# Access Compliance Report

## Public Rights-of-Way

Intersection ID: 11363	Main Street: N_POPLAR_ST	Cross Street: W_12TH_ST	Location: N
ADA ID: 80FAEBCFEFAA	Ramp Type: Perp	Initial Pass/Fail: Fail	Overall Compliance: No
			Severity Score: 33.75

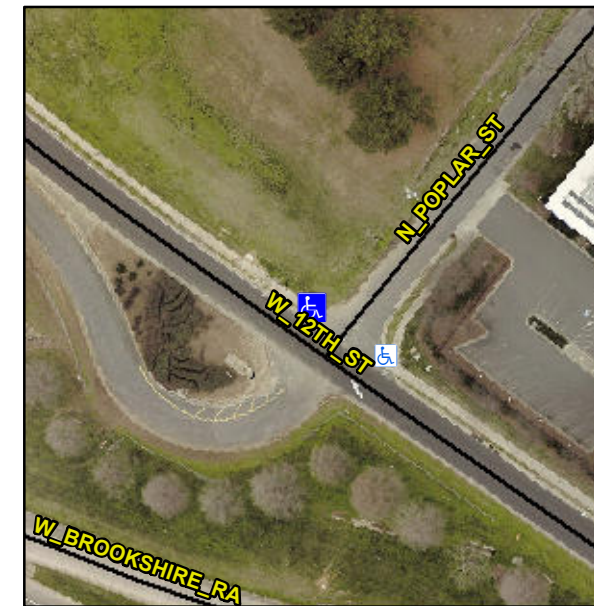
**Not Found, R304.5.1, R304.2.2, R304.5.3**

Compliance	Description	Data	Compliance	Description	Data
N/A	Ramp Length (in)	35.0	No	Ramp Slope (%)	9.5
No	Ramp Width (in)	40.0	No	Ramp XSlope (%)	6.1
N/A	Flare Type LT	N/A	N/A	Flare Type RT	N/A
N/A	Flare Slope LT (%)	N/A	N/A	Flare Slope RT (%)	N/A
N/A	Flare Traversable LT?	N/A	N/A	Flare Traversable RT?	N/A
N/A	Landing Length (in)	N/A	N/A	DWS Provided?	N/A
N/A	Landing Width (in)	N/A	N/A	DWS Contrast?	N/A
N/A	Landing Slope (%)	N/A	N/A	DWS Length (in)	N/A
N/A	Landing X Slope (%)	N/A	N/A	DWS Full Width?	N/A
N/A	Landing Curb? (Y/N)	N/A	N/A	DWS Offset (in)	N/A
N/A	Shared Landing?	N/A			
N/A	Gutter Ponding?	N/A	N/A	Gutter Slope (%)	N/A
N/A	Gutter Lip Ht (in)	1.0	N/A	Gutter X Slope (%)	N/A
N/A	Painted X Walk1?	No	N/A	Painted X Walk2?	N/A
	X Walk 1 Direction	To SE		X Walk 2 Direction	N/A
N/A	X Walk 1 Width (in)	N/A	N/A	X Walk 2 Width (in)	N/A
	X Walk 1 Slope (%)	2.7		X Walk 2 Slope (%)	N/A
	X Walk 1 X Slope (%)	2.9		X Walk 2 X Slope (%)	N/A

**Remove & Replace Entire Ramp.**
